FutureGen Industrial Alliance, Inc.
73 Central Park Plaza East
Jacksonville, IL 62650
www.FutureGenAlliance.org

Subject: Request for Additional Information #2 Regarding, FutureGen Applications for UIC Permit nos. IL-137-6A-0001, -0002, -0003 & -0004, November 14, 2013

11-14-2013: Letter from Rebecca Harvey (EPA) to Kenneth K. Humphreys (Alliance), "Request for Additional Information Regarding four FutureGen 2.0 Wells, United States Environmental Protection Agency Underground Injection Control (UIC) Permit Applications for Four Geologic Sequestration Wells; United States Environmental Protection Agency UIC Permit Nos. IL-137-6A-0001, -0002, -0003, & -0004"

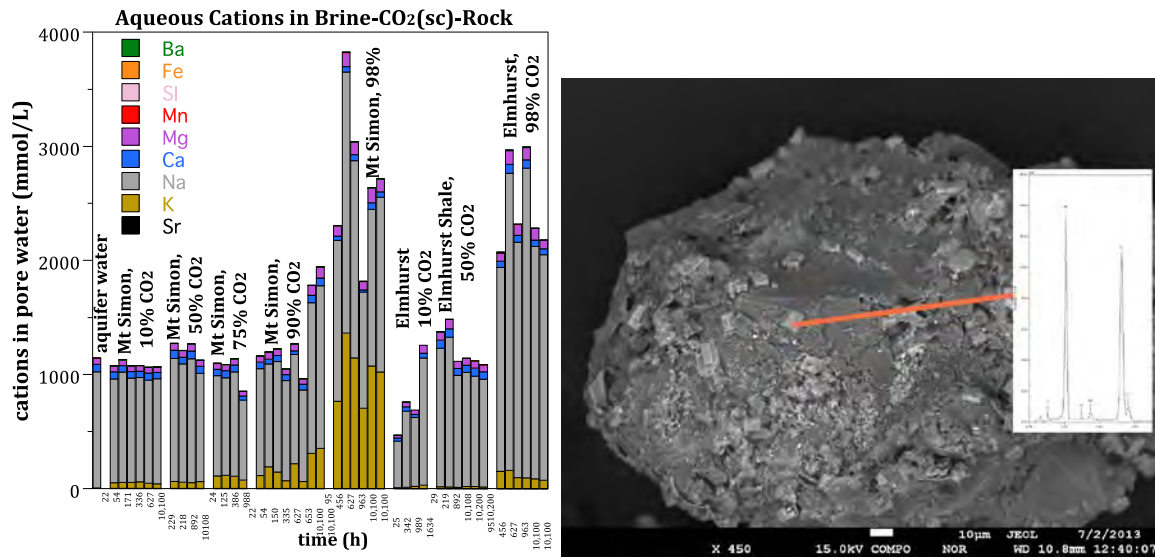
11-14-2013: Letter from Rebecca Harvey (EPA) to Kenneth K. Humphreys (Alliance), "Request for Additional Information Regarding four FutureGen 2.0 Wells, United States Environmental Protection Agency Underground Injection Control (UIC) Permit Applications for Four Geologic Sequestration Wells; United States Environmental Protection Agency UIC Permit Nos. IL-137-6A-0001, -0002, -0003, & -0004"							
Requests based on the text application							
RAI #	Subject	Page	Doc. Sec.	Par.	EPA Comment / Question / Request	FutureGen Response	Footnote / Reference Citation
11-14-2013_001	Physical Processes Modeled	3.3	3.1.2		"Page 3.3 of the permit application states that laboratory investigations for quantifying the importance of chemical reactions are being conducted. Are any results available? Modeling considering reactive transport may need to be conducted if the lab results indicate significant iron carbonate precipitation that changes injection zone porosity."	Based on its experiments, the FutureGen Alliance (the Alliance) expects to see a small mass of precipitates (KCl, NaCl) forming near the injection well from the scCO ₂ displacement of water, and does not expect to see the formation of any significant carbonate precipitates in this year (or years) time scale. Iron does precipitate, but concentrations are too low (<0.6 mmol/L) relative to carbonate mass to be a precipitate issue. Simulations by others (White et al. 2005) of scCO ₂ injection in a similar sandstone (also containing iron oxides) shows that over significantly longer time scales (1000+ years), aluminosilicate dissolution and aluminosilicate precipitation incorporating significant carbonate (dawsonite) is predicted, as well as precipitation of some calcite. That predicted mineral trapping did permanently sequester 21% of the carbonate mass, thus decreasing scCO ₂ transport risk. A more detailed response to this request showing some experimental results is presented in Appendix A .	White, S.P., R. Allis, J. Moore, T. Chidsey, C. Morgan, W. Gwynn, and M. Adams. 2005. Simulation of reactive transport of injected CO ₂ on the Colorado Plateau, Utah, USA. <i>Chemical Geology</i> 217:387-405.

The experiments were conducted at different brine/scCO₂ ratios (0% to 98% scCO₂) in Mount Simon Sandstone, Eau Claire shale, and St. Peter Sandstone formations for the purpose of characterizing a) changes in water quality, and b) significant phase changes (i.e., precipitates) that may affect further injection. NaCl and KCl precipitates were observed forming at high scCO₂/brine ratios (Figure 1b) over time, as water partitions into the scCO₂, leaving ions behind that eventually precipitate (i.e., “salting out”). This is most likely to occur near injection wells. Major ion changes over the year (Figure 1a) are generally small, with only Na⁺ and K⁺ increase with 98% scCO₂ (with a corresponding increase in Cl⁻ [not shown]). Iron is observed to precipitate at nearly all scCO₂/brine ratios, but given the initial iron concentration of 0.6 mmol/L, the formation of siderite [Fe(II)CO₃] is expected only to be a relatively minor precipitate, and was not observed in the microprobe analysis of the scCO₂-treated Mount Simon samples. There were indications of mineral dissolution, with increasing Mg²⁺, K⁺, and SO₄²⁻ concentrations (10s to 100s of mmol/L) and a minor increase in silica. In the White et al. (2005) simulations, as the pH increased from 3.8 (acidic due to the scCO₂) to 4.8 over 105 years, the major mineral precipitates formed were aluminosilicates kaolinite [Al₂Si₂O₅(OH)₄] and dawsonite [NaAlCO₃(OH)₂], with a small increase in calcite precipitation, with corresponding dissolution of aluminosilicates albite [NaAlSi₃O₈], anorthite [CaAl₂Si₂O₈], and K feldspar [KAlSi₃O₈].

Therefore, the Alliance expects to see a small mass of precipitates (KCl, NaCl) forming near the injection well from the scCO₂ displacement of water, and does not expect to see the formation of any significant carbonate precipitates in this year (or years) time scale. Iron does precipitate, but concentrations are too low (<0.6 mmol/L) relative to carbonate to be a precipitate issue. Modeling by others (White et al. 2005) in a similar sandstone (also containing iron oxides) shows that over significantly longer time scales (1,000+ years) significant aluminosilicate dissolution and aluminosilicate precipitation incorporating significant carbonate (dawsonite) is predicted, as well as some precipitation of calcite. That predicted mineral trapping did permanently sequester 21% of the carbonate mass, thus decreasing scCO₂ transport risk.

Figure 1. Slabbed core photos of the Lombard, illustrating the heterolithic nature of this interval.

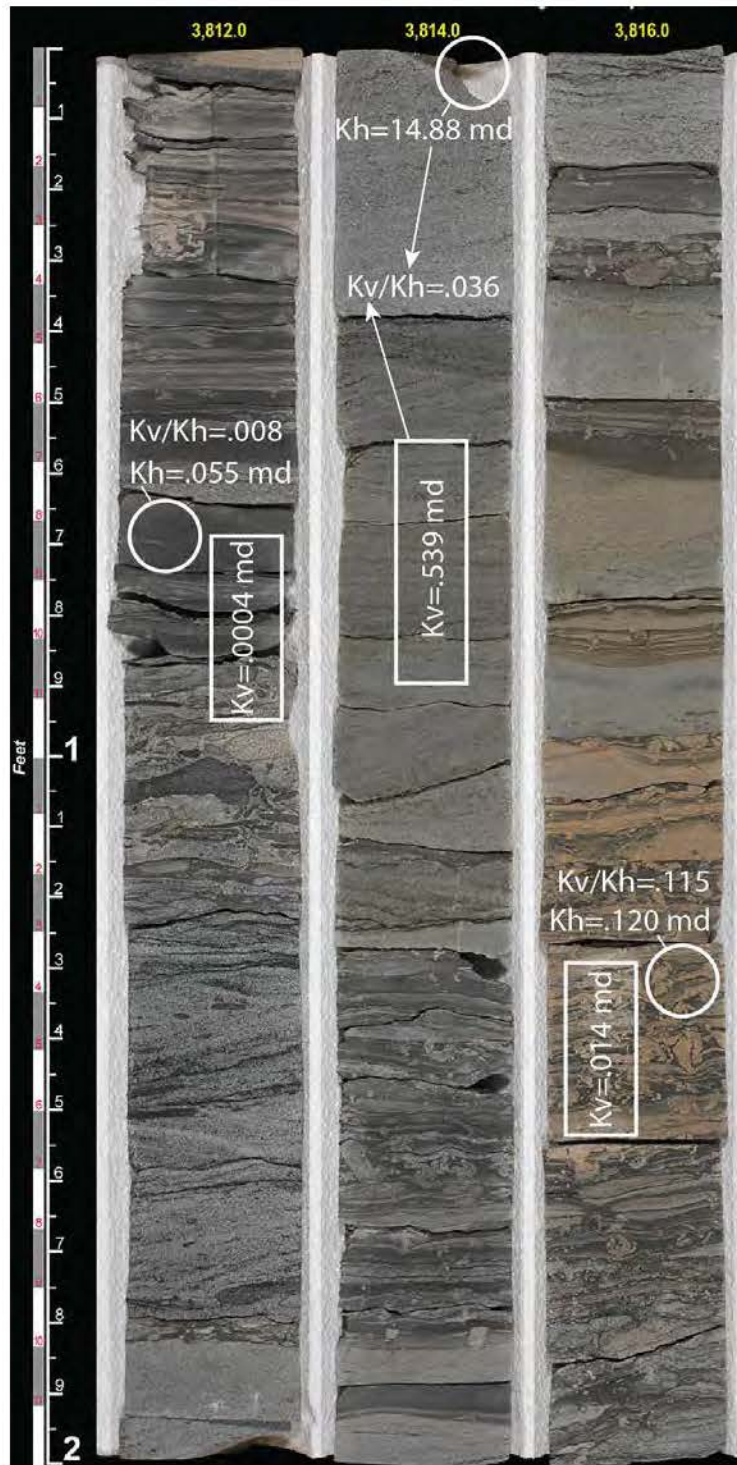
11-14-2013_003	Intrinsic Permeability in the Injection Zone		3.1.3.2	2	"No hydrologic tests were conducted in the Elmhurst formation to measure a Permeability-Thickness Product and no ELAN calculation was given. How was a Permeability-Thickness Product determined for the Elmhurst formation?"	No permeability-thickness product has been determined for the Elmhurst Formation. The permeabilities used for this formation were the ELAN-based PermKcal values without applying a scaling factor.	
11-14-2013_004	Vertical Permeability		3.1.3.2	3	"Kv/Kh measured in 20 core plug pairs; highly related to presence of mudstone/shale; sparse data led to use of literature values. Given that 20 ratios were successfully determined, how do they compare to the literature values?"	Table 3.4 of the UIC permit Supporting Documentation has been updated to show the Kv/Kh literature values for model layers that have measured values and the corresponding 20 measured Kv/Kh data points. The complete response to this request is discussed in Appendix B

It should be noted that there is no available whole core from the confining layers; and available rotary sidewall cores do not provide sufficient sample size for vertical measurements of permeability. The Lombard is extremely heterolithic, as observed in the attached core photos (Figure 1), but the sparse individual sample pairs suggest that the literature value represents a very conservative value, and that vertical permeability is lower than modeled.

Figure 3.21. CO₂-Rich Phase Saturation for the Representative Case Scenario Simulations Shown at Selected Times (5, 10, 20, 70, and 100 years).

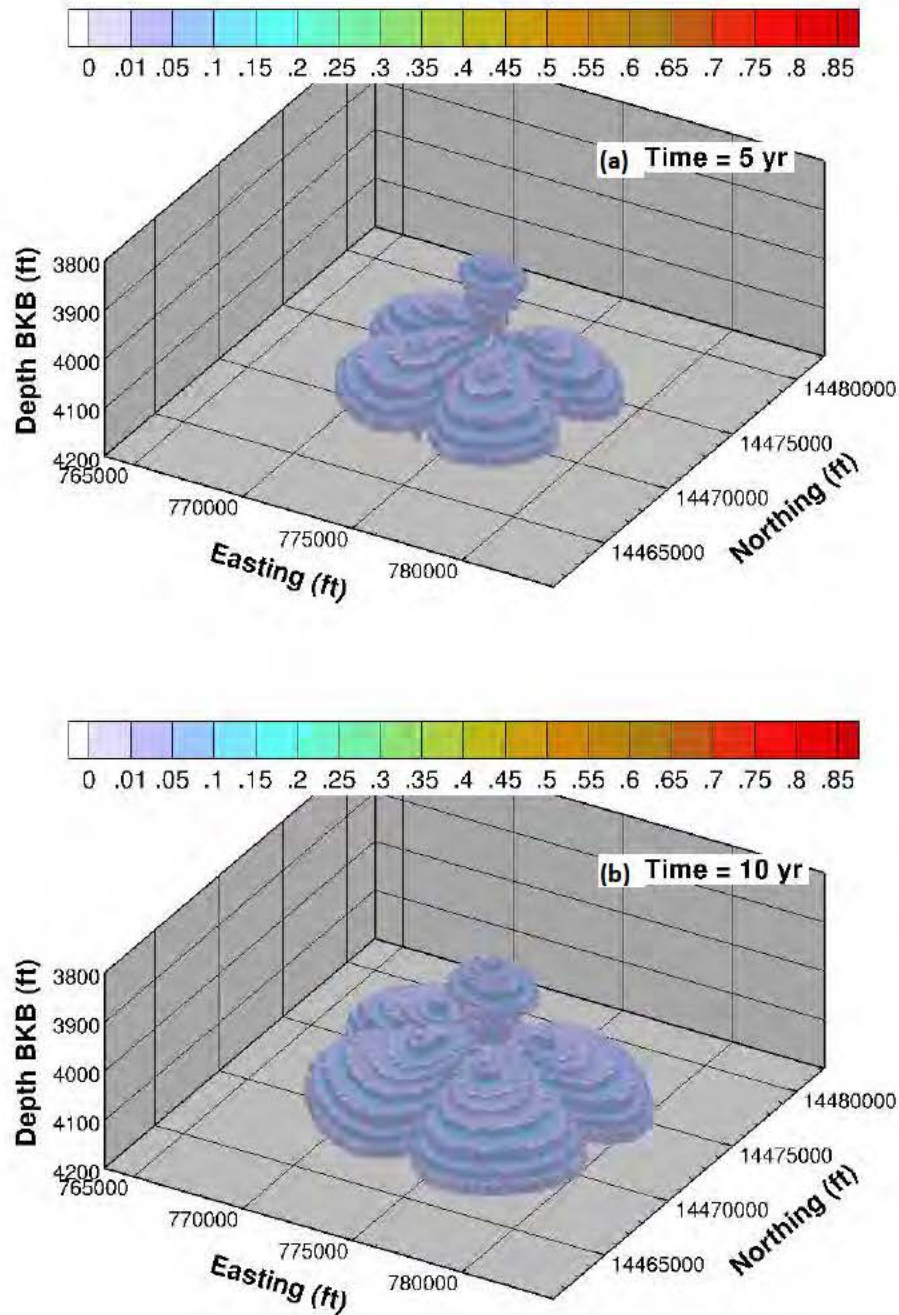
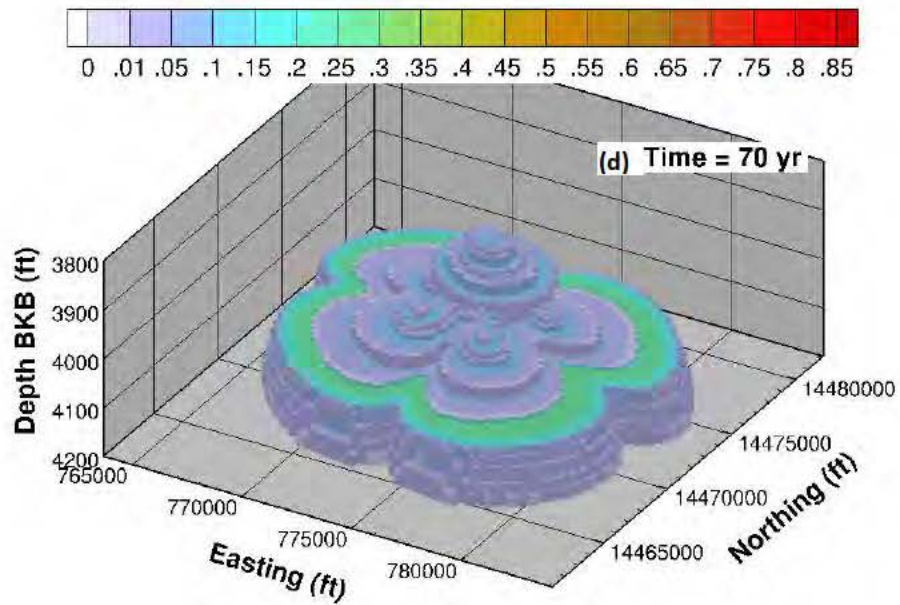
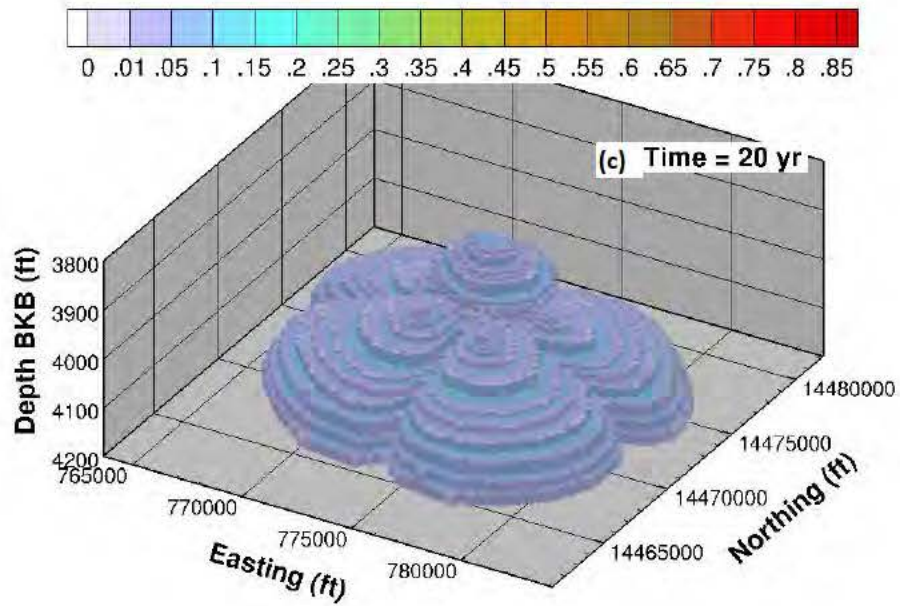
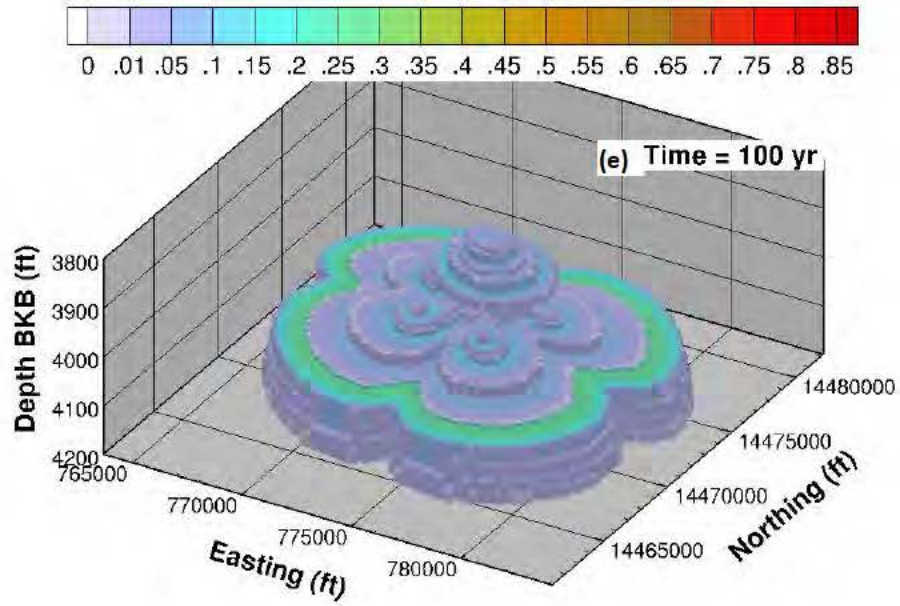
11-14-2013_010	Computational Model Results		3.1.6	2	"Please provide figures beyond year 70. We suggest figures to year 100."		
11-14-2013_011	Parameter Sensitivity and Uncertainty		3.1.10	1	"32 cases were defined using "quasi Monte Carlo" approach. <i>This approach should be described and possibly cited.</i> "	An extensive response to RAIs 11-14-2013_011 and 11-14-2013_012 is presented in Appendix D .	
11-14-2013_012	Parameter Sensitivity and Uncertainty		3.1.10	2	"The permit application states that 32 cases were defined from the representative case model. The parameter values used for these 32 cases should be presented in a table."

The last paragraph and associated figures of Section 3.1.6 (Computational Model Results), beginning on page 3.29, were updated (as excerpted below) to describe the CO₂ migration processes. In addition, a plot corresponding to 100 years was added to each of the following figures: 3.21, 3.22, and 3.23. Furthermore, Figure 3.24 was replaced with plots showing the pressure differential and the CO₂ plume boundary at the same scale and in the horizontal plane (map view) for the same times. For convenience, the plots in each figure are marked with letters “a” through “e.” Please refer to the response to RAI# 11-14-2013_018 for information about the pressure front.

“Reservoir conditions are such that the CO₂ remains in the supercritical state throughout the domain and for the entire simulation period. The three-dimensional distribution of the CO₂-rich (or separate-) phase saturation is presented for selected times (i.e., 5, 10, 20, 70, and 100 years) in Figure 3.21. Additionally, and to better illustrate the CO₂ migration through time and space, a cross-sectional view of the CO₂ plume is presented as slices through the center of the injection wells and along the well traces (see Figure 3.18 for location of cross sections). Figure 3.22 and Figure 3.23 show the CO₂-rich (or separate) phase saturation for selected times for slices A-A’ and B-B’, respectively. Note that Figure 3.21 shows the plume in model coordinate space, while Figure 3.22 and Figure 3.23 show the distance from the center of the injection well pad. This is necessary because the well orientation is not aligned with the x and y axes of the model domain.

The cloverleaf pattern of the CO₂ plume that forms as a result of the four lateral-injection-well design can be seen in Figure 3.21a, which shows the plume after 5 years of continuous CO₂ injection. The central portion of the plume is a result of CO₂ injection into the Elmhurst in the vertical section of each well. Figures presenting the cross-sectional views show the location of the open interval relative to the plume and stratigraphic units. It can be seen in Figure 3.22 and Figure 3.23 that after 5 years of continuous CO₂ injection, the plume has spread both laterally and vertically, with some CO₂ migrating into the lower part of the Lombard. At 10 and 20 years, with more CO₂ being injected, the plume grows larger with time primarily in the lateral direction, but also vertically. Two years after the cessation of CO₂ injection (at 22 years), the plume reaches its maximum lateral extent (a comparison of the plume outline at different times in plan view is shown in Figure 5.1). However, the CO₂ within the plume continues to redistribute by migrating slowly upward due to buoyancy effects, with some of the CO₂ dissolving at the CO₂-brine interface at the edge of the plume. The vertical layering represented in the model is one of the controlling factors in the plume shape at later times. In general, the CO₂ tends to accumulate below a layer with a relatively higher gas entry pressure (and often lower permeability) than that of the layer directly below it. This area of relatively higher CO₂ saturation can be seen in Figure 3.21d and Figure 3.21e as the green “ledge” feature in the plume, and in Figure 3.22d, Figure 3.22e, Figure 3.23d, and Figure 3.23e as the flat-topped orange zone. Because the plume migrates primarily upward after injection ceases, the green feature becomes narrower with time (Figure 3.21d and Figure 3.21e). The vertical cross sections showing the plume at 100 years illustrate how the CO₂ distribution within the plume becomes more uniform with time (Figure 3.22e and Figure 3.23e). Because of the dissolution process, the CO₂ separate-phase plume area (in the horizontal plane) at 100 years is 2.2% smaller than the maximum area at 22 years.

Figure 1. Klinkenberg correction factor as a function of K-Klinkenberg for all analyzed FutureGen core plugs.

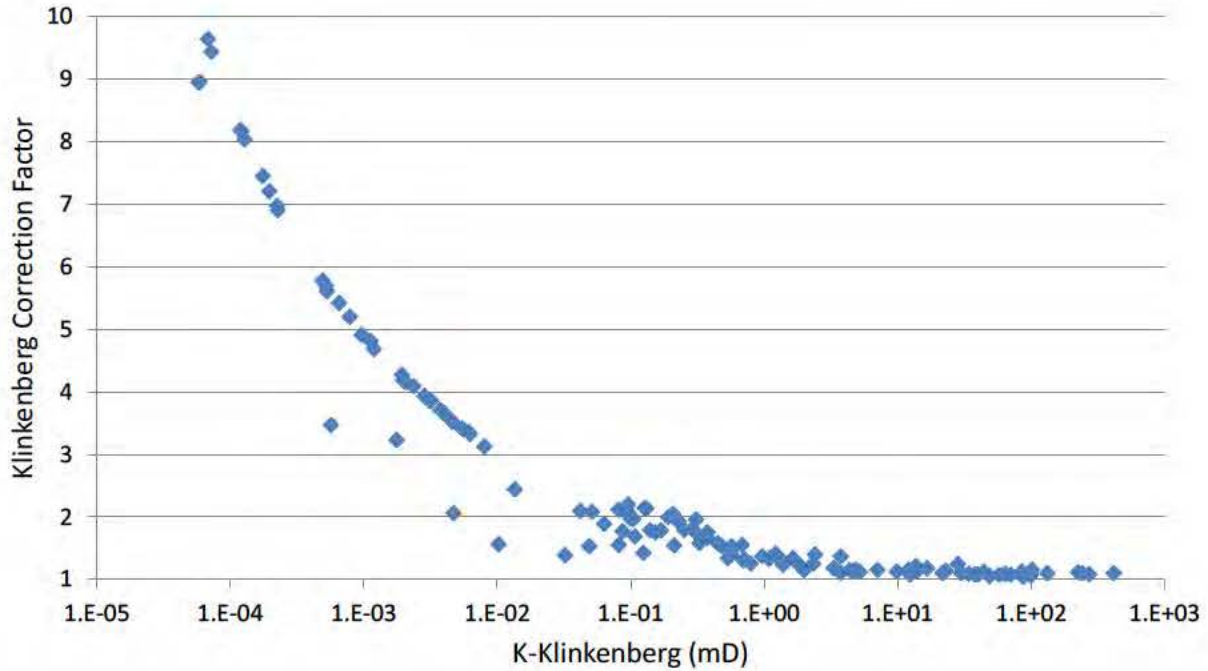
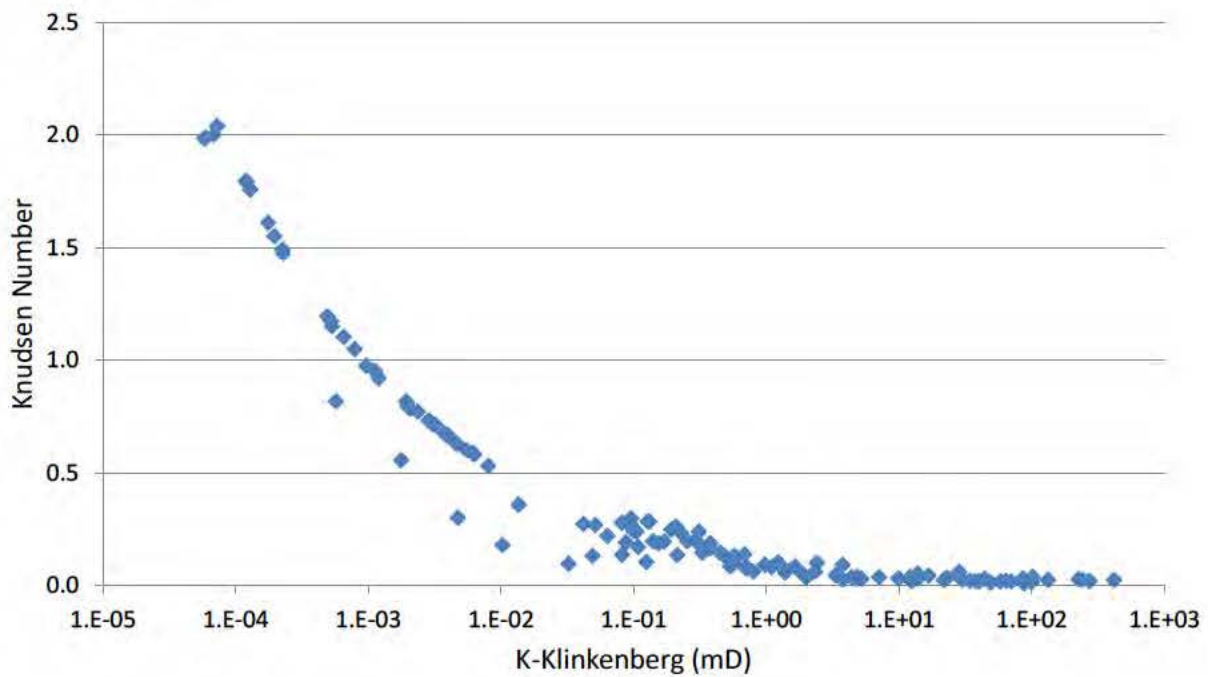
11-14-2013_015	Rocks Properties	2	"Horizontal intrinsic permeability of the confining zones (see p. 3.7 of the permit application). Because of the reliability issues associated with ELAN log derived permeabilities below a certain limit (0.01 mD), FutureGen used the horizontal Klinkenberg permeabilities for each model layer. Was there any correction applied to the Klinkenberg permeabilities used for the confining zone layers, particularly because these may represent tight porous formations?"	Additional permeability corrections beyond the Klinkenberg correction were not applied. The K-Klinkenberg values were computed from K-air values, measured by Core Laboratories using an unsteady state method, using the Klinkenberg Correction Factor (KCF). The KCF values were obtained for each sample using a standard procedure (Jones 1972). An extensive discussion is presented in Appendix E .	Jones, S.C. 1972. A rapid accurate unsteady-state Klinkenberg permeameter. <i>Society of Petroleum Engineers Journal</i> 383-397.

Additional permeability corrections beyond the Klinkenberg correction were not applied. The K-Klinkenberg values were computed from K-air values, measured by Core Laboratories using an unsteady-state method, using the Klinkenberg Correction Factor (KCF). The KCF values were obtained for each sample using a standard procedure (Jones 1972). For some tight rocks it has been shown that the KCF may not be sufficient and that larger correction factors, such as the Knudsen correction factor, might be needed. The determination of whether a standard Klinkenberg can be used is typically based on the values of the Knudsen number, Kn ($Kn = \lambda/r$ where λ is the molecular free path and r is characteristic length such as pore radius). For Knudsen numbers below ~ 2 , differences between the KCF and the Knudsen correction factor are relatively small and additional permeability corrections are typically not needed (e.g., Ziarani and Aguilera 2012).

In Figure 1 (below), the computed KCF values are plotted against K-Klinkenberg for all analyzed samples. The plots show that for the tighter rocks (K-Klinkenberg < 0.01 mD), the KCF are always less than 10. Based on literature analyses (e.g., Civan 2010; Ziarani and Aguilera 2012), KCF values less than 10 indicate that the tighter samples are, in terms of the Knudsen flow regime, located in the lower end of the transition flow zone where $0.1 < Kn < 10$. To confirm this observation, Kn values are computed using Eq. D1 for λ and Eq 17 for r in Ziarani and Aguilera (2012) and plotted in Figure 2 vs. K-Klinkenberg. The plot shows that for the tighter cores, $Kn < 2$. For these Kn values, the Knudsen correction factor may be up to 10% to 20% larger than the KCF. However, given the inherent uncertainties of unsteady-state permeability measurements in the < 0.01 mD range (Rushing et al. 2004), the slightly larger correction factor would result in permeability values within the experiment measurement error.
